# Bristol-Myers Squibb Company

DOCKET NO.: 030-05222  
CONTROL NO.: 124288  
LICENSE NO.: 29-00139-02

**RESPONSE TO NRC REQUEST FOR ADDITIONAL INFORMATION - LICENSE #29-00139-02**

This is in reference to your application dated February 18, 1997 requesting to renew Nuclear Regulatory Commission License No. 29-00139-02. In order to continue our review, we need the following additional information:

DR.: R.G.		E. R. SQUIBB & SONS, INC. NEW BRUNSWICK, N. J.		C.A.R.:																					
DATE: 9-27-88				P.N.: 124-196																					
SCALE: NTS		MODIFICATION TO STACK SAMPLING SYS.		D.M.:																					
CH.				DRAWING NUMBER																					
APPD.

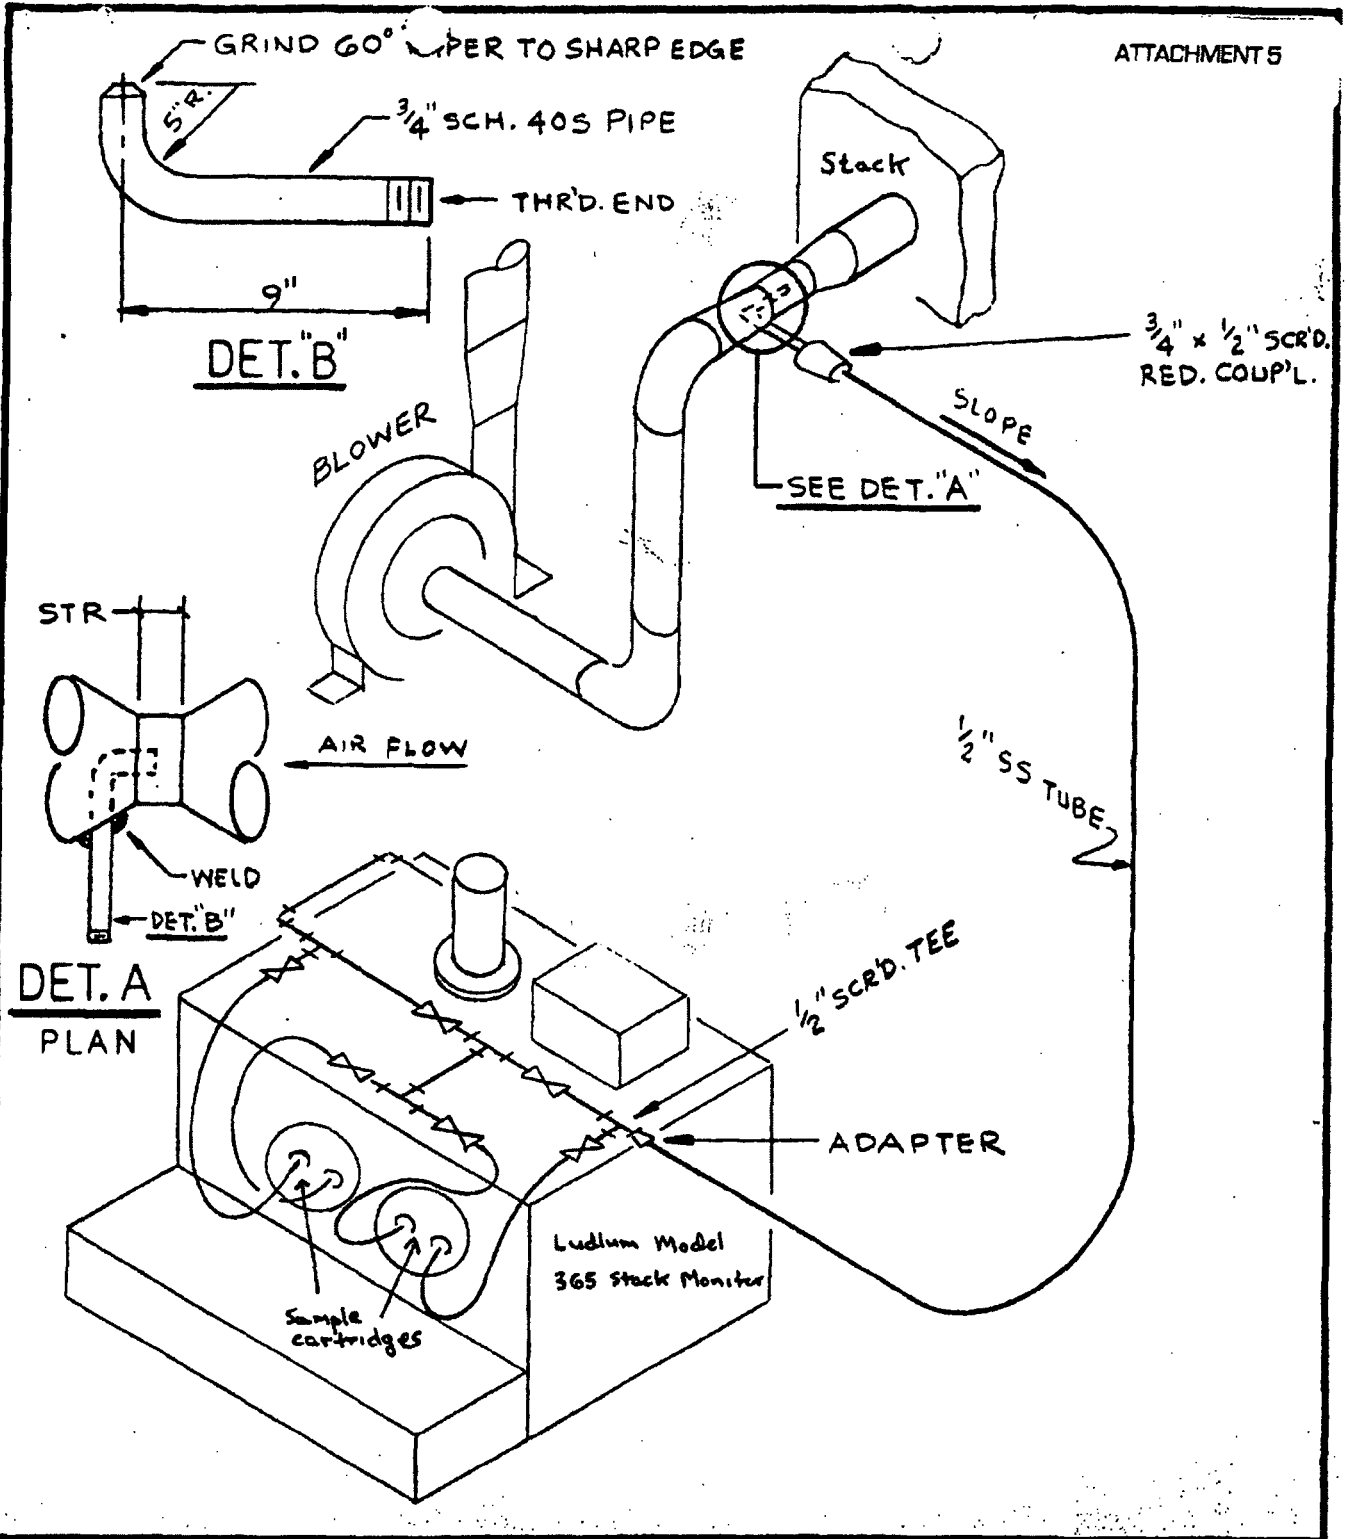
Provide a schematic drawing showing the location of the sample cartridge and the stack alarm detector. Paragraph #5 on page 1-8 states: "The radioactivity in the sampler is constantly measured by the stack alarm detector which will sound an alarm in the Health Physics operations area should the integrated activity representing the 24 hour effluent limit for I-131 as specified in Appendix B, Table II, Column I of 10 CFR 20 be exceeded." Provided specific details about the stack alarm detector, and specify whether the alarm setpoint(s) interact with the HVAC system.
